**EDMONTON  
TRIBUNALS**

*Subdivision &  
Development  
Appeal Board*

Date: May 25, 2018  
Project Number: 278798859-001  
File Number: SDAB-D-18-074

**To construct a Public Education Services Use building (Larkspur 7-9 School)**

ENCLOSURE I  
 DA 278798859-001  
 April 18, 2018

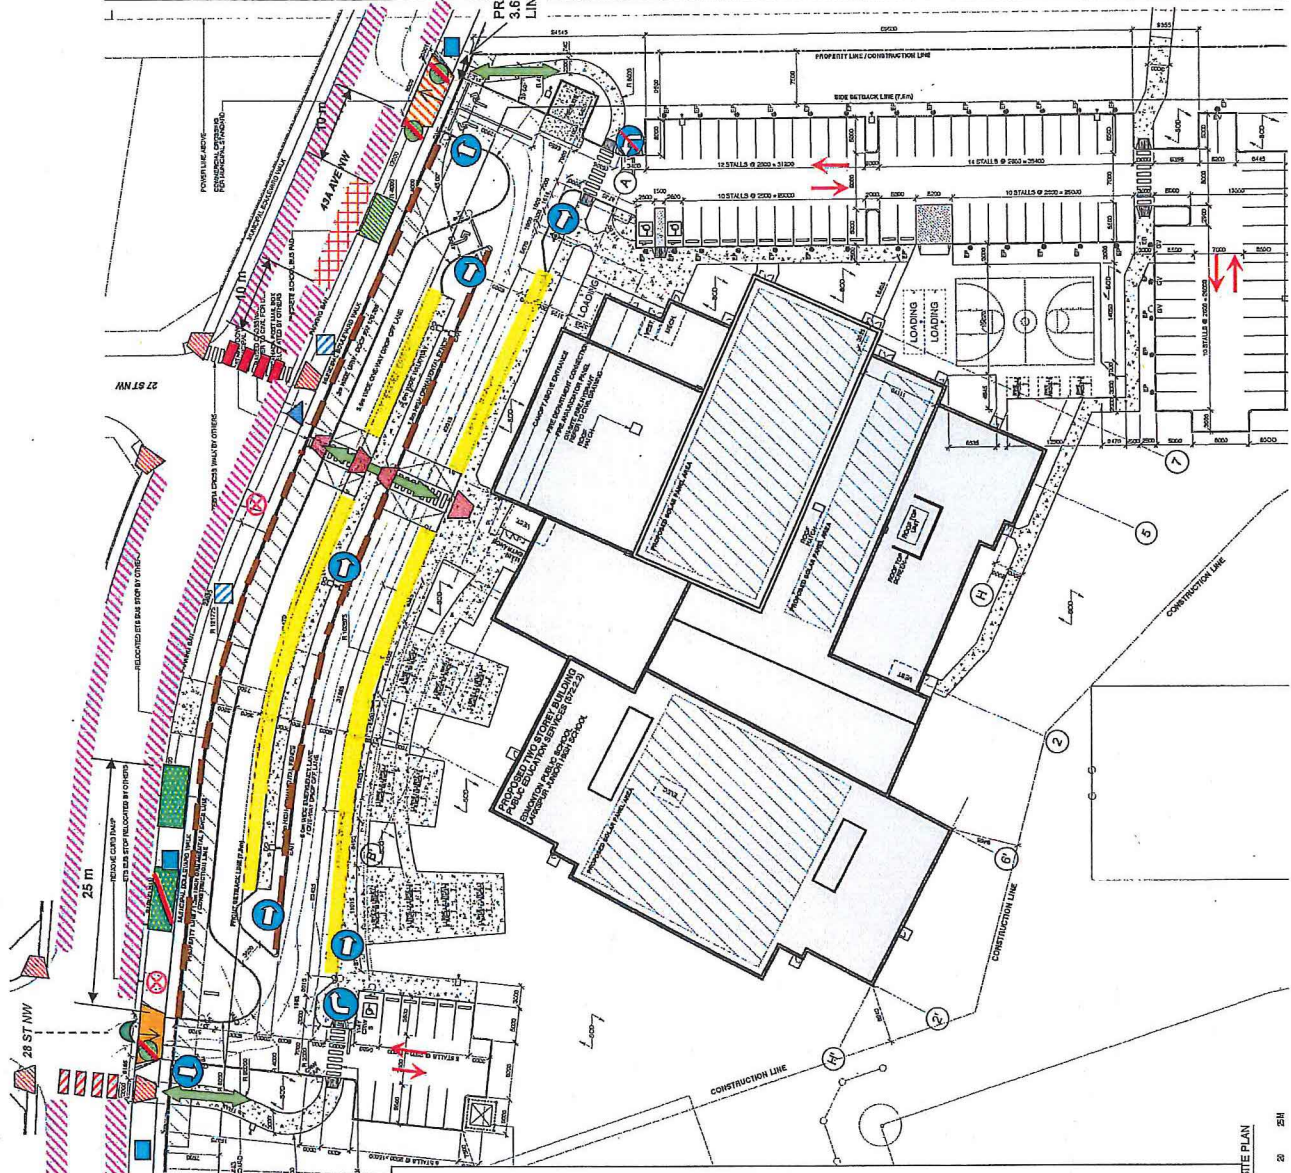
- l) relocation of any above or underground utilities impacted by the proposed school construction.
3. The proposed 6 m access to 43A Avenue shall align with the outbound lane of 28 Street and must be constructed as a commercial crossing access to City of Edmonton Standards, as shown on Enclosures I and II. This proposed access must maintain 1 m minimum separation from the existing curb ramp and operate as a one-way inbound only access.

4. The proposed 8 m access to 43A Avenue located approximately 3.6 m from the east property line, is acceptable to Subdivision Planning and must be constructed as a commercial crossing access to City of Edmonton Standards, as shown on Enclosures I and II. This proposed access must operate as a one-way outbound only access.

5. The existing curb ramps located on the southeast intersection of 28 Street and 43A Avenue, and southwest intersection of 27 Street and 43A Avenue must be removed as shown on Enclosure I. Curb and gutter must be constructed and the boulevard must be restored.

6. The installation of a zebra marked crosswalk with signage is required on 43A Avenue on the east side of 27 Street. All zebra marked crosswalks with signage shall be completed with the development of the school, as shown on Enclosure I. The installation must coincide with the opening of the school to facilitate the increased pedestrian traffic. Please contact Alex Mawanay (780-496-2667) of Traffic Safety and Brad Vander Hoek (780-496-3080) of City Operations to initiate the installation. Further upgrade details regarding the crosswalk will be reviewed at the engineering drawing stage.

7. A street lighting assessment has been completed at the location of the required zebra marked crosswalk on 43A Avenue to review whether the street lighting meets TAC Guidelines. The assessment identified that luminaire upgrades are required to two (2) existing street lights in the vicinity of the crosswalk on 43A Avenue at 27 Street with development of the school, as shown on Enclosure I. Please contact Shawn Jacobs (780-496-3527) of City Operations for further information.

8. There are three (3) boulevard trees located along 43A Avenue that will require removal, as shown on Enclosure I. All costs associated with removal, compensation value for the tree and a replacement tree will be borne by the

9. There is an existing Edmonton Transit bus stop along 43A Avenue in the vicinity of the proposed 6 m access. This bus stop must be removed and reconstructed as a 9 m x 3.5 m bus stop pad located 25 m east of the proposed 6 m access is required, as shown on Enclosure I.

10. A school bus stop pad must be located a minimum of 10 m west of the proposed easterly access, as shown on Enclosure I. The construction of a 5 m x 3.5 m bus pad is required along 43A Avenue to provide connectivity from the school bus to the public sidewalk.

12. There is a catch basin in the vicinity of the proposed 6 m access to this property that will require modifications, as shown on Enclosure I. The applicant must contact Kimberly Cochrane with Drainage Planning at 780-496-4292 to coordinate the modification of the catch basin. Further details will be reviewed at the engineering drawing stage.

14. There is an existing street light in the vicinity of the proposed 8 m access to 43A Avenue, as shown on Enclosure I. The access must maintain a minimum clearance of 1.5 m from the street light. Should relocation of the streetlight pole be required, all costs associated with relocation must be borne by the owner/applicant. The applicant should contact Jesse Cummings at 780-412-7780 of EPCOR Technology & Meter Services if relocation is required.

15. The proposed one-way directional accesses must be properly signed on private property indicating the operation of the access, as shown on Enclosure I.

16. The onsite one-way directional drive aisles, including the on-site operation of the staff parking lots entry/exit access from the one-way drive aisle, and the onsite drop off stalls must be properly signed, as shown Enclosure I.

17. The proposed sidewalk connections provided from the public sidewalk to the school building including the marked crosswalks along the internal roadways, as shown on Enclosure I, are acceptable to Subdivision Planning. Additional onsite curb ramps and pedestrian signage must be provided to accommodate these pedestrian connections.

18. A 1.2 m ornamental fence must be installed on private property along 43A Avenue to mitigate any possible conflict between pedestrian and vehicle movement. The proposed fence, as shown on Enclosure I, is acceptable to Subdivision Planning.

ENCLOSURE II  
 DA 278798859-001  
 April 18, 2018

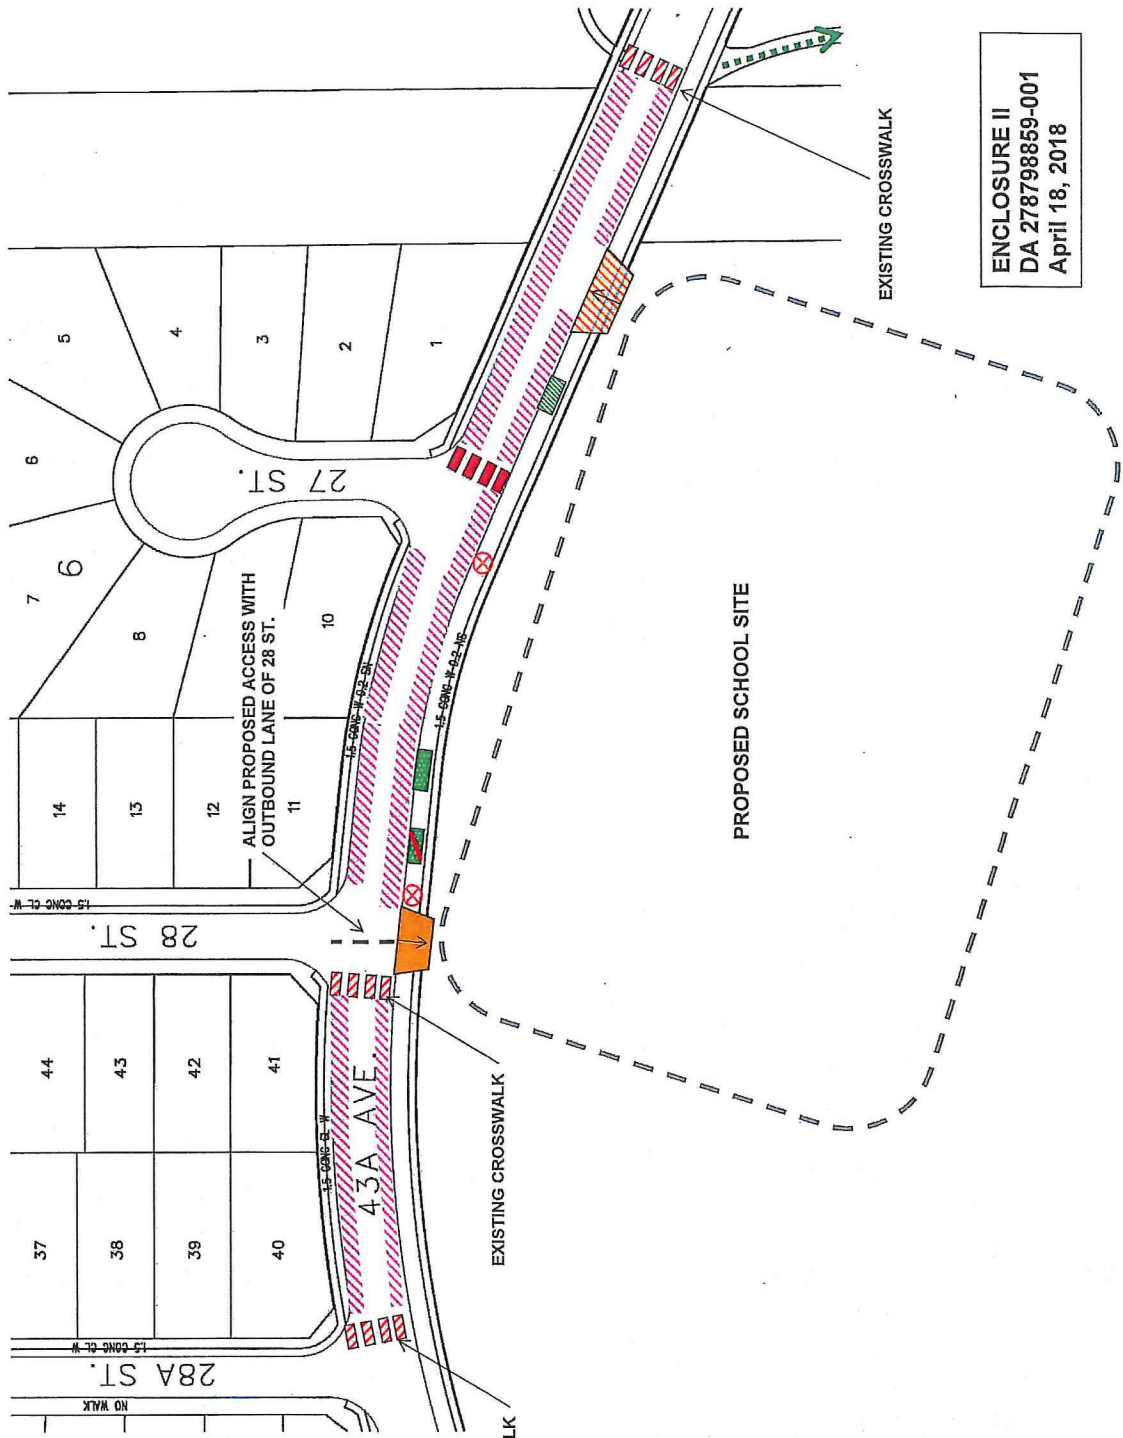
13. A 'no stopping' zone is required along the north and south side of 43A Avenue, as shown on Enclosures I and II, between 28A Street and the existing shared use path located east of the school site. Signage is required to be "no stopping" during school hours from 7:00 – 16:00. Outside of the 'no stopping' hours, no parking is permitted within 10 m of an access, the school bus stop, the Edmonton Transit bus stop and marked crosswalks. Appropriate signage for these areas must be completed at the applicant's expense as part of the school development.
